WOKINGHAM
BOROUGH COUNCIL

Full Planning Approval Consultation

Site Address: Ladds Garden Village, Bath Road, Hare Hatch, Wokingham, RG10 9SB

MEMORANDUM

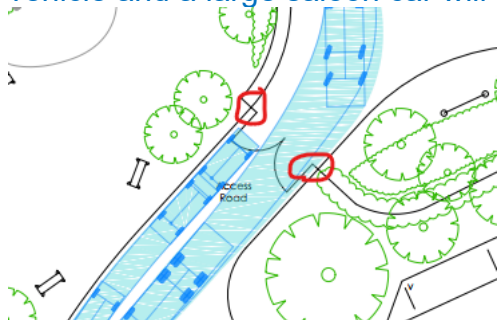
The Highways also expect to review swept paths showing that a refuse vehicle and a large saloon car can pass each other. [This is submitted as supplementary details in Drawing No. ITB210007-GA-008A. The Highways are aware that both the refuse vehicle and a large saloon car will overrun the gate post as circled below:](#)

It is relevant to note that the vehicle body and chassis of the refuse vehicle will overrun the edge of the carriageway at Plot 13 [in Drawing No. ITB210007-GA-002E](#). Minor revision on road alignment will be expected.
